SB18050035
IVECO STRALIS Cursor 11 (Euro 6)
Special Option Front Traverse

VEHICLE WITHOUT THE SPECIAL OPTION FRONT TRAVERSE:
KIT KC13080337 → NOT SUITABLE

VEHICLE WITH THE SPECIAL OPTION FRONT TRAVERSE:
KIT KC13080337 → SUITABLE

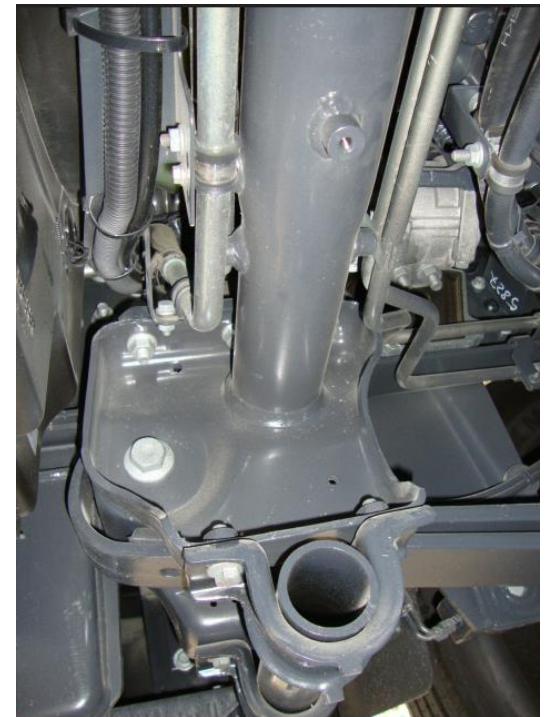
The front traverse is moved forward, so that to install the kit.
This modification must be done by Iveco Workshop.

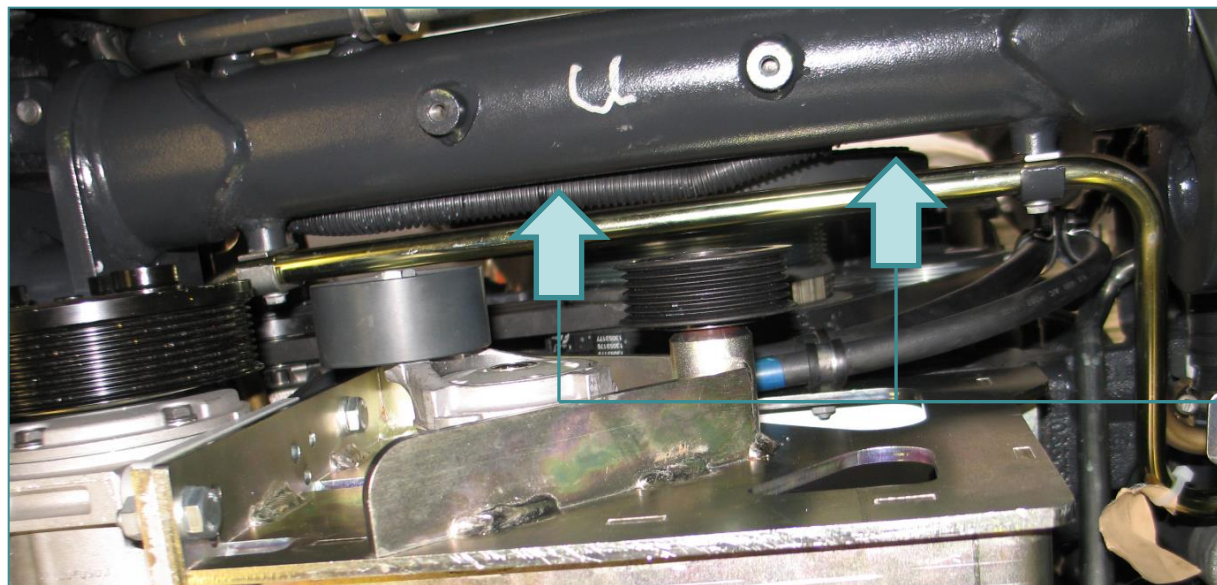
**The trucks come from factory
always with this configuration**
